SUBJECT: Forwards second 10-yr inservice insp interval Request for Relief 93-01 for Class 1 or 2 welds on reactor vessels. Due to actual physical barriers, coverage on at least 90% of weld vol not possible.

Subject: Duke Power Company
Oconee Nuclear Station
Docket No. 50-269
Second Ten Year Inservice Inspection Interval
Request for Relief No. 93-01

Subject LIMITED EXAM DATA FOR THE RPV FLANGE TO SHELL WELD

Subject LIMITED EXAM DATA FOR THE RPV LIGAMENT AREA

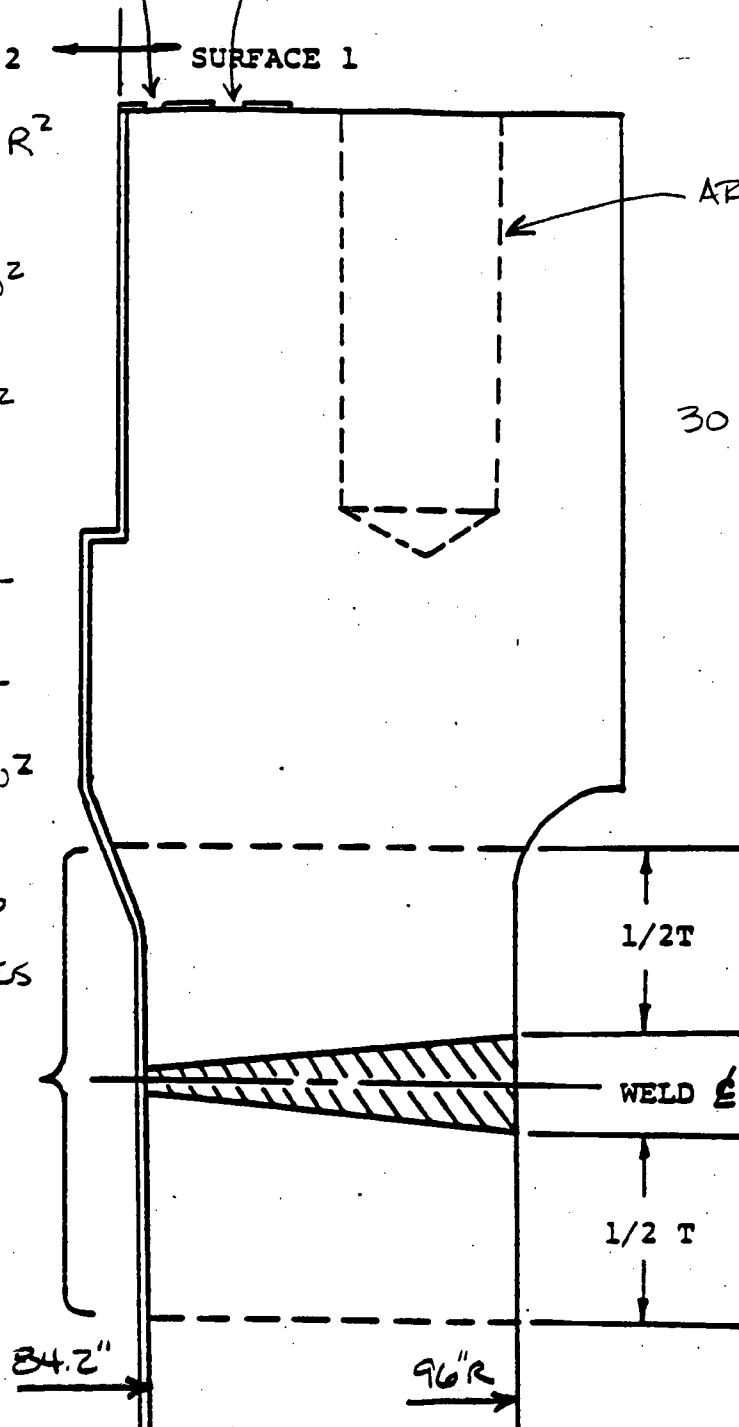
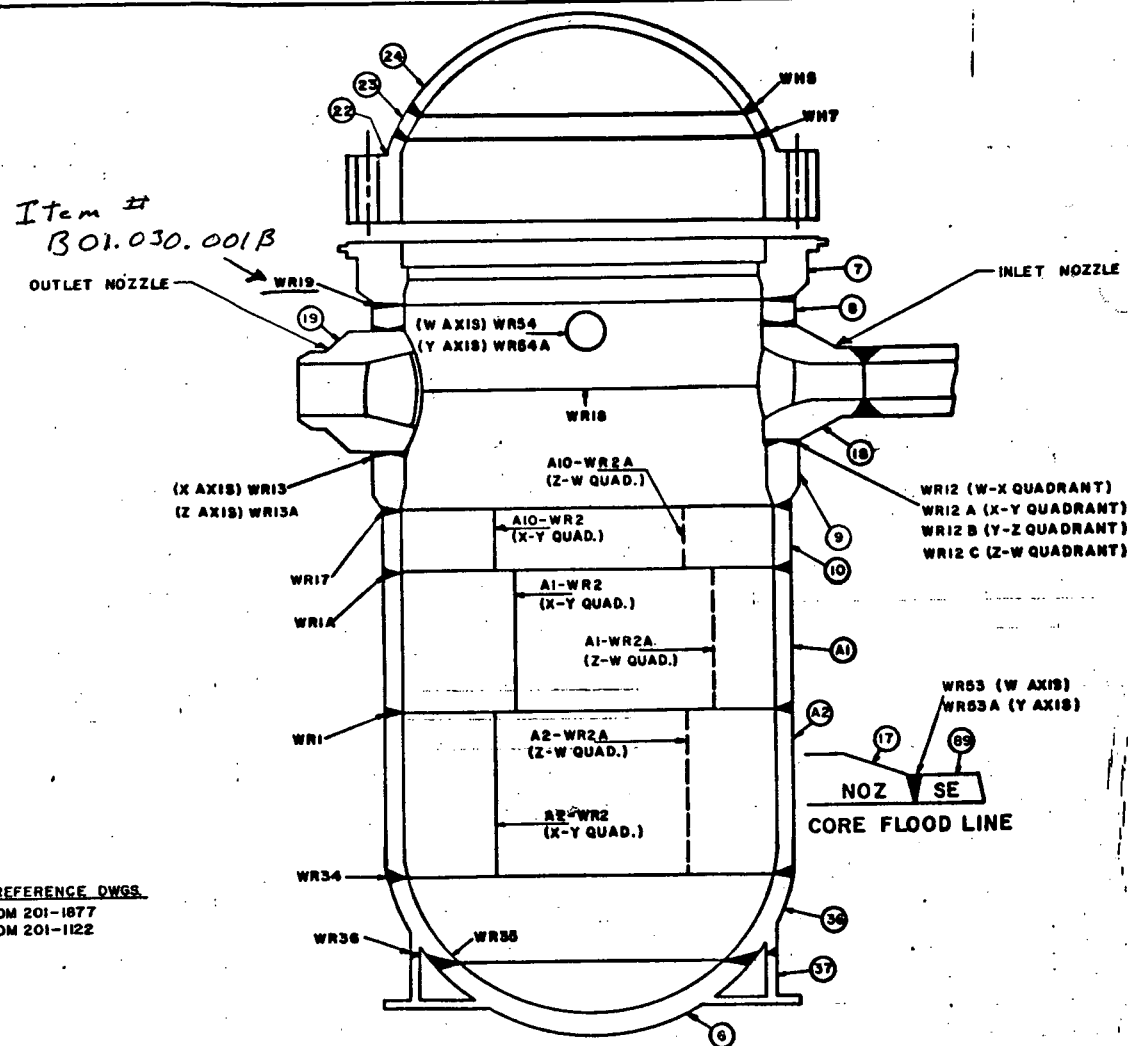
Item No.	Exam Category /Figure No.	System Or Component	Function	Area To Be Examined	Reason For Request ¹	Licensee Proposed Alternate Examination
B01.030.001B	B-A IWB2500-4	Reactor Vessel	Contains the fission process	Flange to Shell	Limited scan due to location of holes in Reactor Vessel Flange. Actual coverage = 55.8%	None
B06.040.001A	B-G-1 IWB-2500-12	Reactor Vessel	Contains the fission process	Threads in Reactor Vessel Flange	Limited scan due to part geometry and location of holes to clad area. Actual coverage obtained = 84.5%.	None

ACTUAL COVERAGE 55.8%

AREA NOT
SCANNED NOTCH A
= 159.95 IN²

AREA NOT SCANNED
NOTCH B = 163.05 IN²

$$= \text{NOTCH A} + \text{NOTCH B} + 30 \text{ HOLES} \\ = 159.95 + 163.05 + 1154.5 \\ = 1477.5 \text{ IN}^2$$

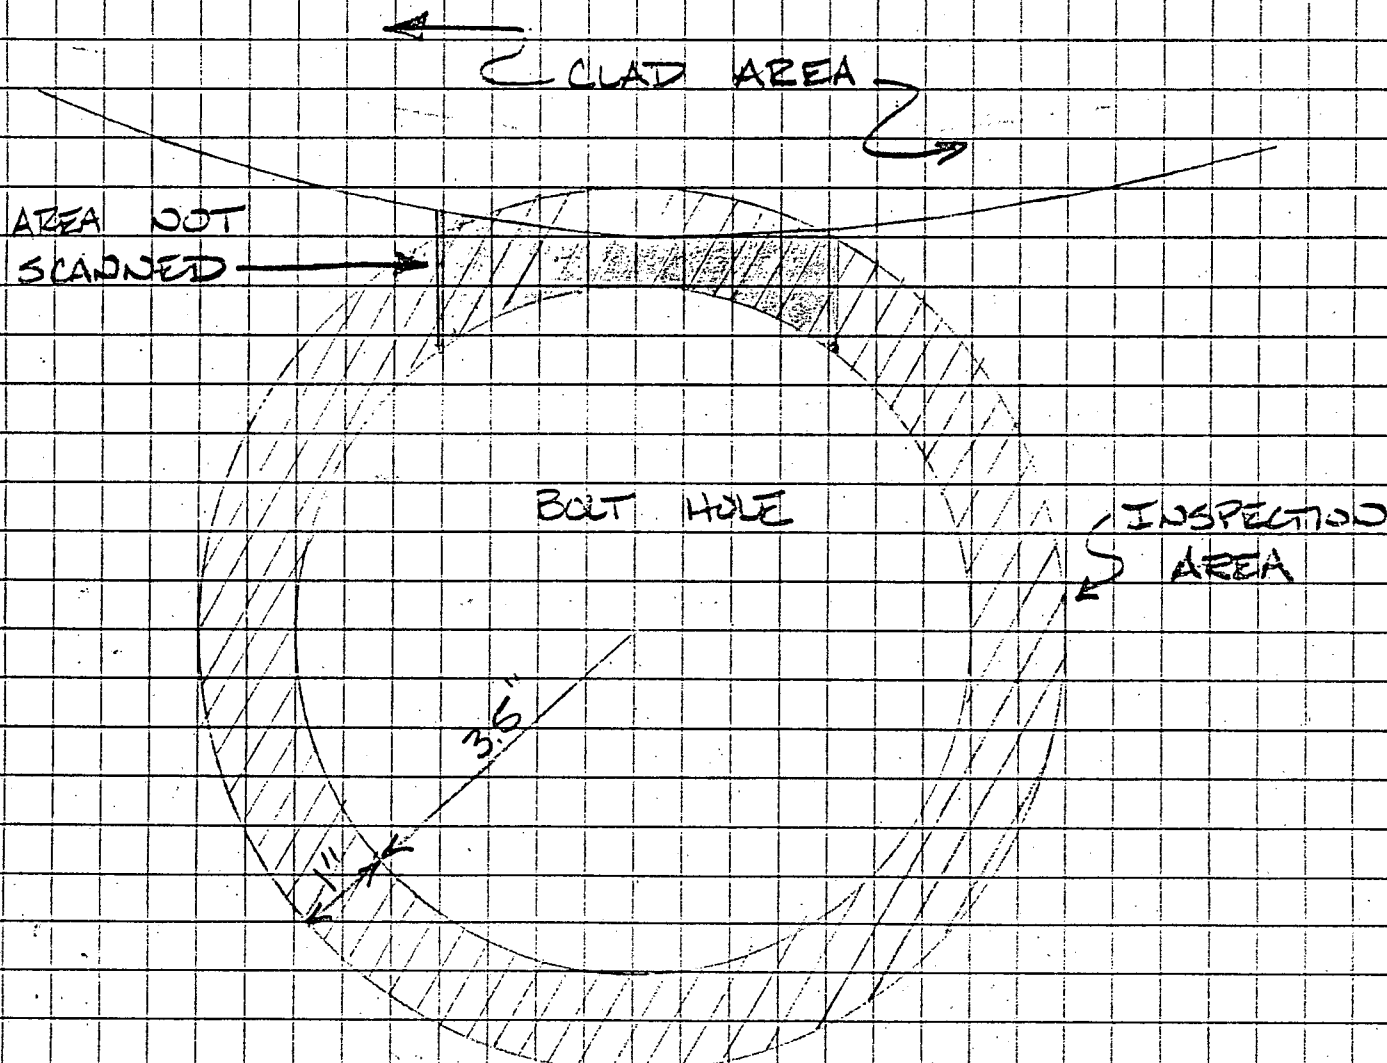
ACTUAL COVERAGE 84.5%

INSPECTION AREA= 25.2 sq. in.

AREA NOT COVERED= 3.9 sq. in.

$\frac{3.9}{25.2} \times 100 = 15.5\%$
